CITY OF ALBUQUERQUE

**Advanced Auto Parts
10800 Unser Blvd. NW
Request Permanent C.O. - Accepted
Engineer's Stamp dated: 4-28-16 (A11D012)
Certification dated: 12-23-16**

GRADING & DRAINAGE PLAN

**Re: Advanced Auto Parts; 10800 Unser Blvd. NW
(A11/D012)**

CG-101

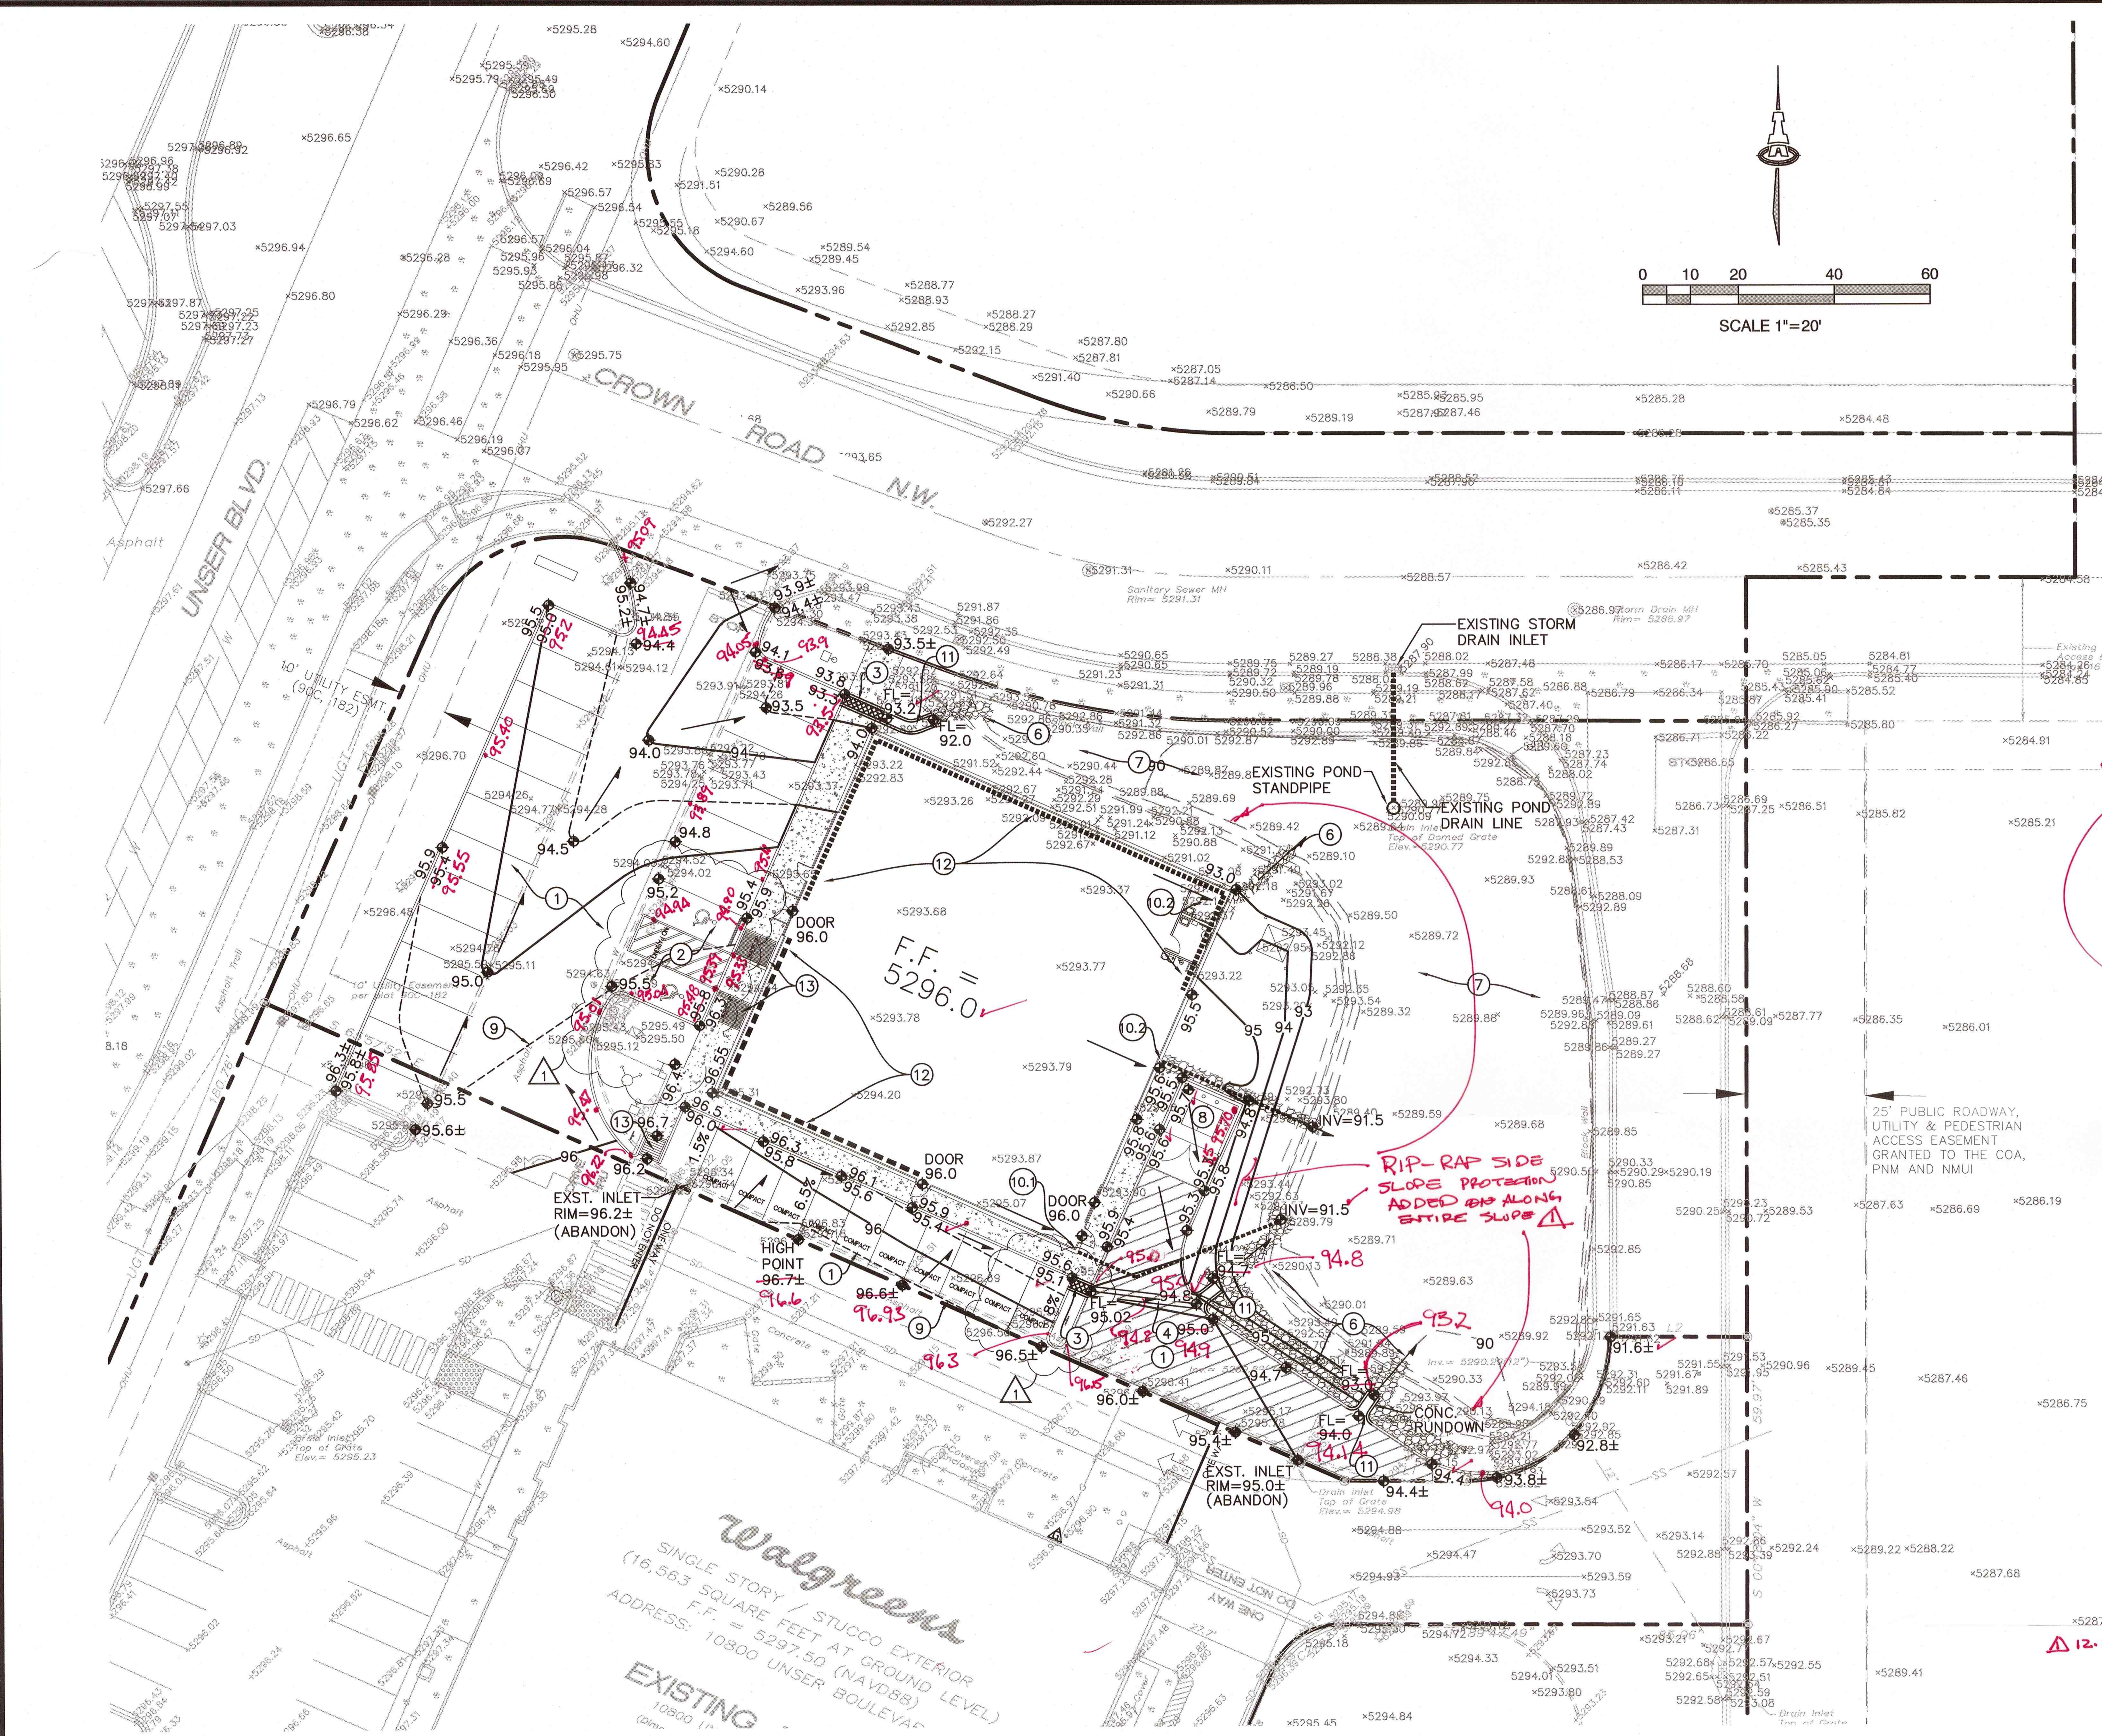
11. CONSTRUCT 2' WIDE (BOTTOM WIDTH) CONCRETE RUNDOWN TO PASS CONCENTRATED FLOW TO POND. INSTALL EROSION PROTECTION FROM END OF RUNDOWN TO POND BOTTOM.
 12. SEE ARCHITECTURAL PLANS FOR INFORMATION REGARDING BUILDING EXTENDED AND RETAINING STEMWALLS REQUIRED TO ACHIEVE SITE GRADES.
 13. CONSTRUCT ADA COMPLIANT ACCESS RAMP. SEE ARCHITECTURAL FOR DIMENSIONS.
- NOT CONSTRUCTED AS RCC; REPLACED WITH APPROPRIATELY SIZED RIPPED RIP-RAP (4" 8" DIA.). - D.K.**

Contractor has been directed to remedy the "Birdbath" at the south corner of the building at and downgrade of the sidewalk culvert.

1. The designed 18" wide sidewalk culverts were constructed as 9½" inside face-face. They have been analyzed as 9" F-F and both satisfy the design requirements as found on the attached Supplemental Design Calculations.
2. The 24" concrete swale (Note #4) has been constructed and the adjacent asphalt paving has a drainage pattern that allows the storm waters to enter onto the swale.
3. The concrete rundown adjacent to the NW corner of the building was replaced by 4"-8" rock rip-rap that was added to the entire south and west side-slopes of the pond. It is an acceptable alternative.

We have indicated items 2 & 3 on the revised G&D As-Built plan.
